TECHNICAL SERVICE BULLETIN

TSB A-GN-OT-0082

Date: August 1, 2025
To: All Service and Parts Managers
From: Technical Services Department
Subject: AHVE Heat Kit Harness Mis-wired

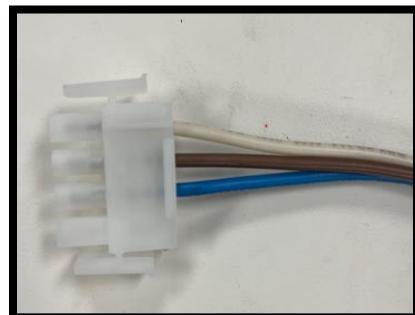
1. Open the control box door. Locate the PCB on the control deck.

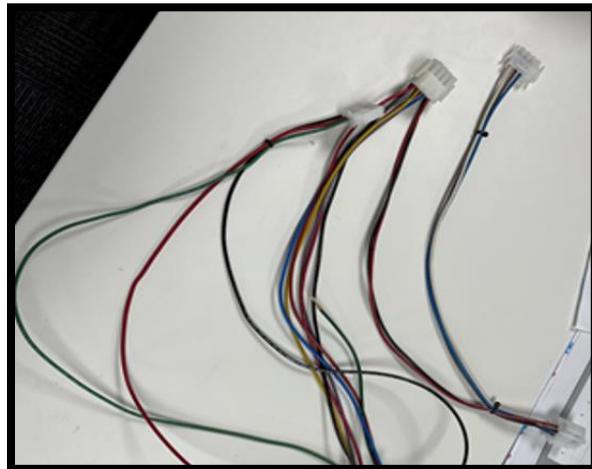
2. Inspect the electric heat connection on the PCB and verify the brown wire is in the middle.

Bad connection with Blue Wire in the Middle

Good connection with Brown Wire in the Middle

3. If the blue wire is found in the middle, swap the blue and brown wire in the connector. If a clean swap is not achievable, then replace with harness part# **0259A00063**.
